GLOBAL SAFETY FIELD INVESTIGATIONS
DCS5541
URGENT - DISTRIBUTE IMMEDIATELY

Subject: N202309750 - Service Update
Radio Changing Station Tuning

Models: 2020 Chevrolet Malibu
2020 GMC Acadia
Equipped with 8" Diagonal Multi-Color Driver Information Center
(RPO UHS)

N202309750 Radio Changing Station Tuning

5431209

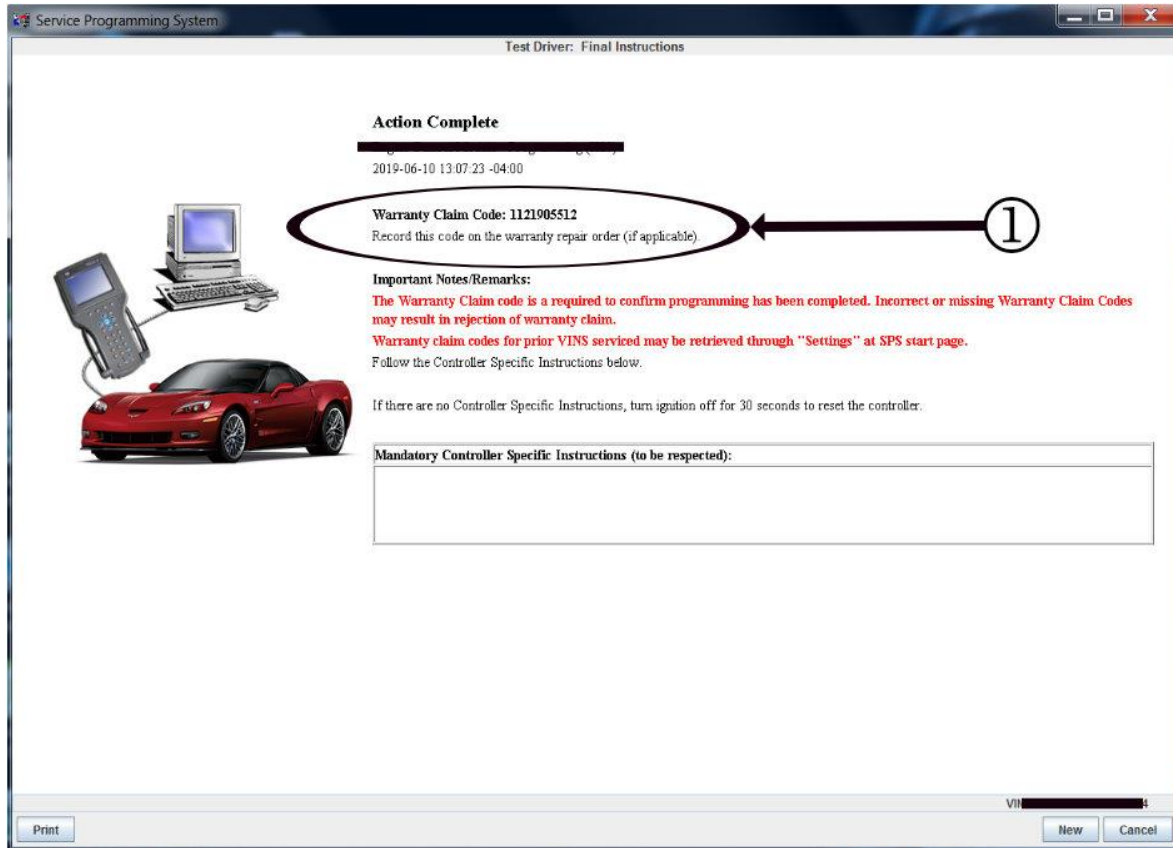
Important: To avoid warranty transaction rejections, you **MUST** record the warranty claim code provided on the Warranty Claim Code (WCC) screen shown above on the job card. Refer to callout 1 above for the location of the WCC on the screen.

5. Record SPS Warranty Claim Code on job card for warranty transaction submission.
